Notice of Determination

Project Title: Syphon Reservoir Improvement Project

Project Description: The proposed project would increase the capacity of the existing recycled water reservoir from approximately 500 acre-feet (AF) to 5,000 AF. The proposed project would replace the existing engineered dam with a new engineered dam, increasing the existing 59-foot dam height to 136 feet and increasing the elevation of the dam crest from the existing 388 feet above mean sea level (amsl) to 466 feet amsl. A new spillway would be included with the new dam to protect the reservoir from overtopping. As part of the new design, the engineered embankment dam would include a seepage control drainage system and a circulation system for the reservoir. The existing strainer and disinfection facilities would be demolished, reconstructed and expanded at the toe of the new dam to provide filtration and disinfection. Additional project features include new onsite access and maintenance roads; wetland and riparian mitigation areas; and potential recreational facilities.

Figure 3.12-1
Regional and Local Roadways

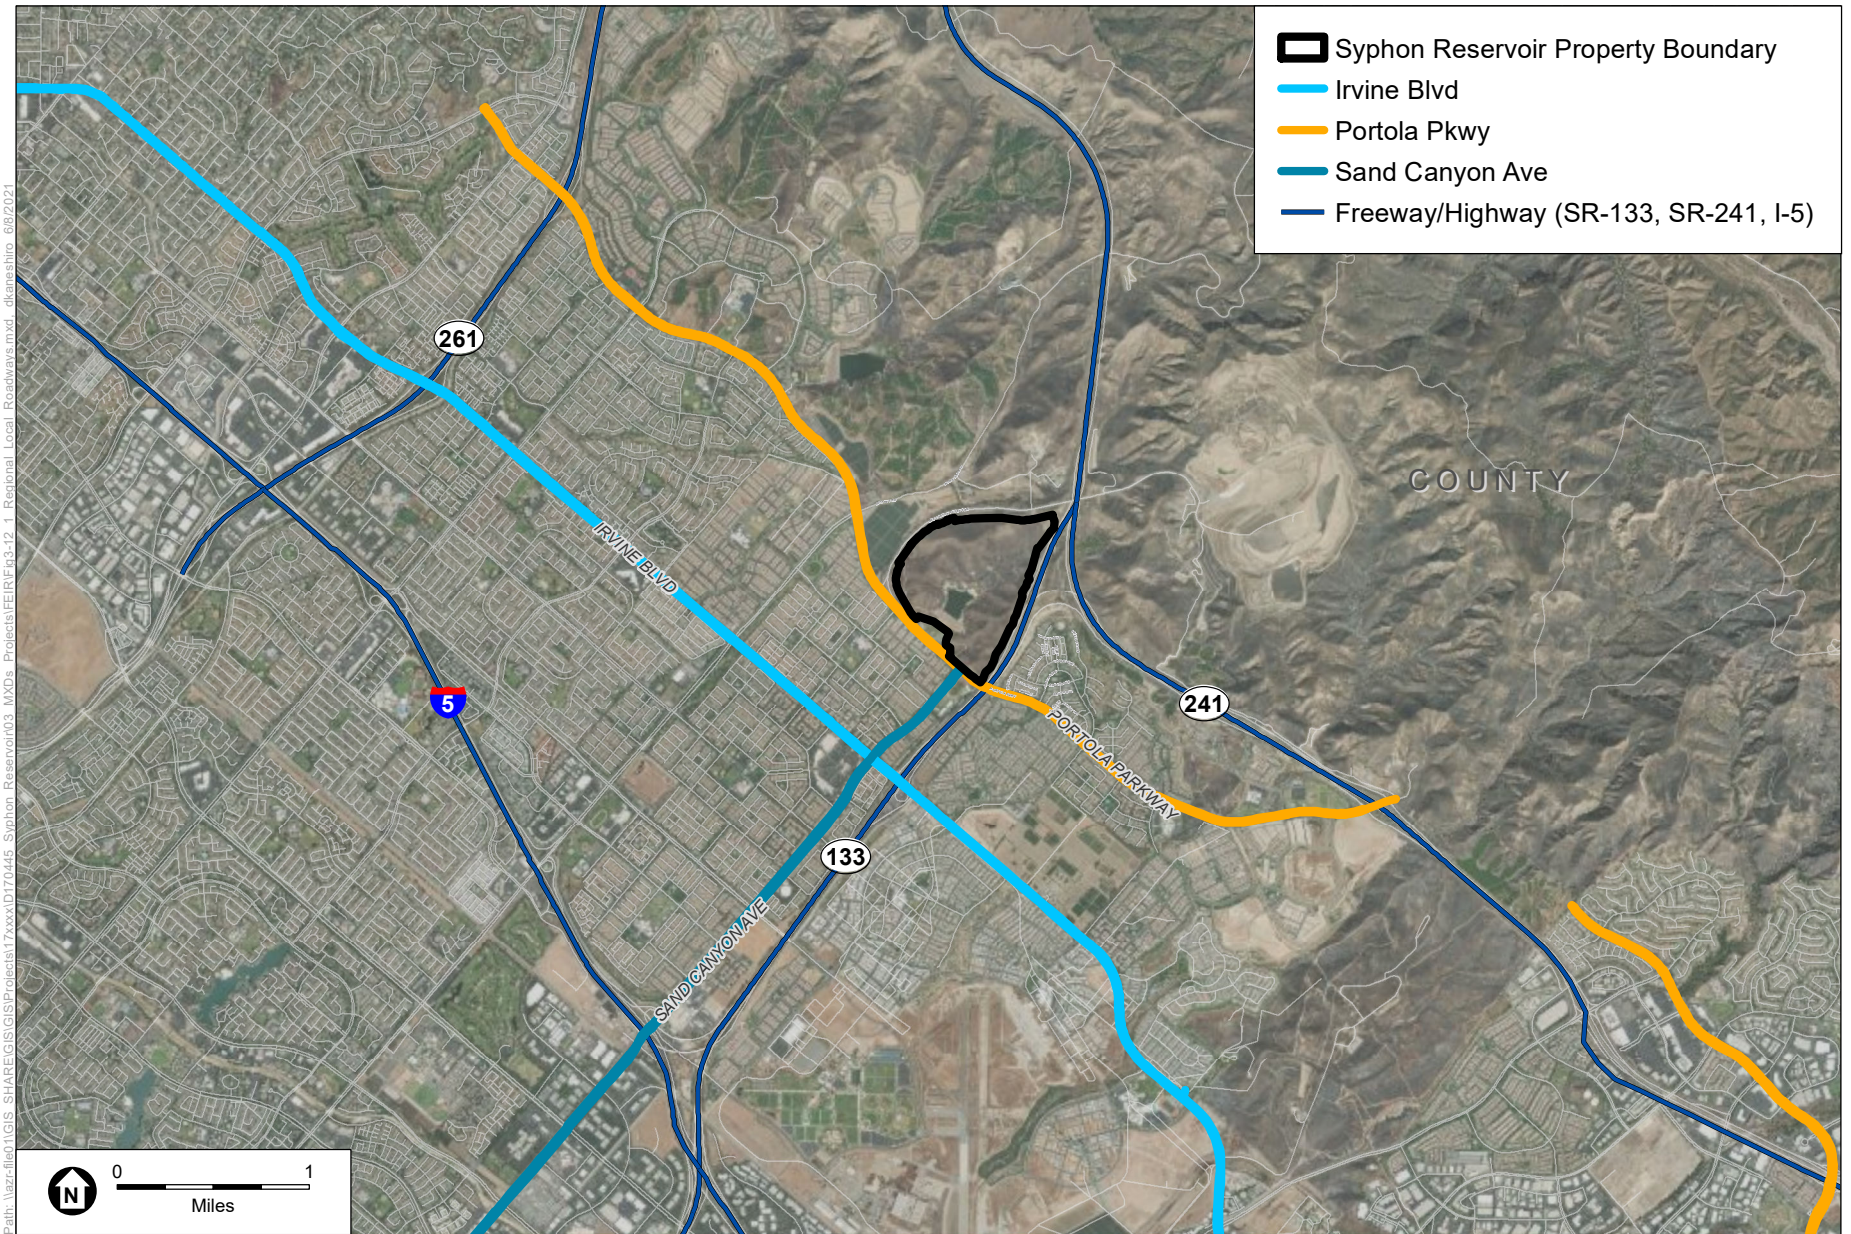
2. Figure 3.12-1 Map legend – please add freeway/highway (I-5, SR-261, SR-241) leg.
3. Consider including a discussion on general transportation safety improvements, especially for vulnerable road users such as bicyclists and pedestrians.

In response to the comment, Figure 3.12-1 has been revised to include freeways/highways and is included in Chapter 11 of this Final EIR.

The legend of **Figure 3.12-1** has been revised to include freeways/highways.
